PL/2025/05762 Armishaw Removals, Netherhampton Road, Netherhampton, Salisbury, SP2 8RA
Mixed-use commercial development including a convenience/food retail unit, a drive-through coffee unit etc,

Figure 2.1 – Indicative 1km and 2km Walk Catchments

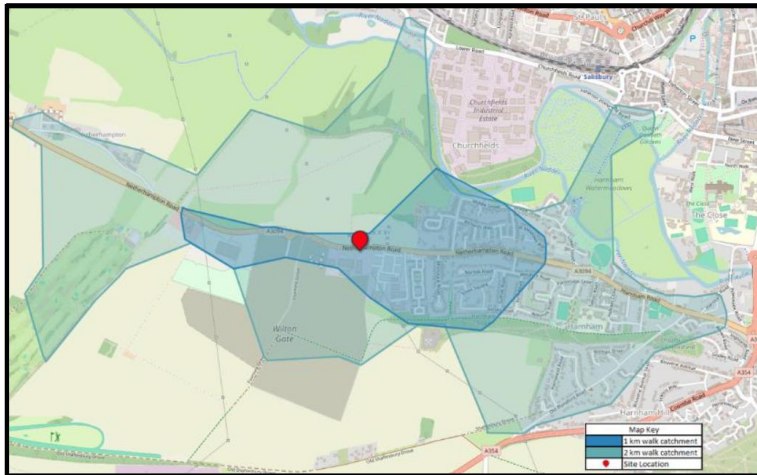
Figure 2-1 from the Transport Assessment (see below), gives the indicative 1km and 2km walk catchment areas. This illustrates how much more accessible the proposed facilities would be to those living and working in Wilton Park if an access point for walkers and cyclists into that development was added to the existing plans. Note the Transport Assessment also makes the point that *“For retail trips, the likely maximum walk distance is 800m due to the fact that shoppers will be carrying bags on their return journey, while for workbased /commuting trips, people are likely to be prepared to walk further.”* [TA 2.2.5]

- (a) plans for pedestrian and cycle access from the adjacent Wilton Gate estate with an entrance to the south of the Armishaws site**
- (b) contributes towards the upgrading of the current informal crossing point across the Netherhampton Road into a safe controlled pedestrian and cycle crossing from the Chapel Gate estate being built on the north side of that road.**
- (c) make changes to the road entrance to the site such that walkers and cyclists on the Netherhampton Road shared use path would have right of way over traffic coming in or out of the site.**
